ATtiny4/5/9/10

Silicon Errata and Data Sheet Clarifications

Figure 1-3. Serial Programming Timing

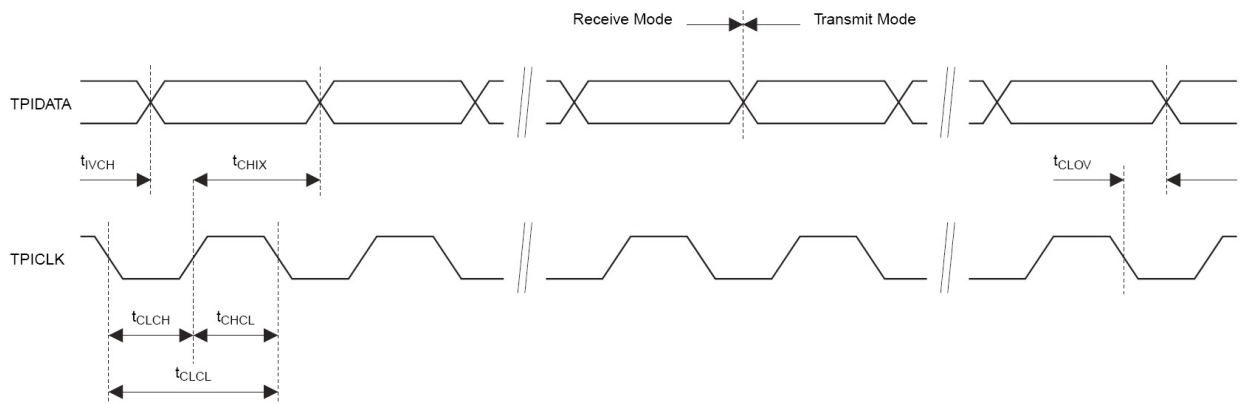
3.2.1 Serial Programming Characteristics

A clarification for the maximum temperature for serial programming, in *Appendix A - ATtiny4/5/9/10 Specification at 125°C* (ww1.microchip.com/downloads/en/DeviceDoc/8127_125.pdf), has been made.

The maximum temperature for serial programming is lowered.
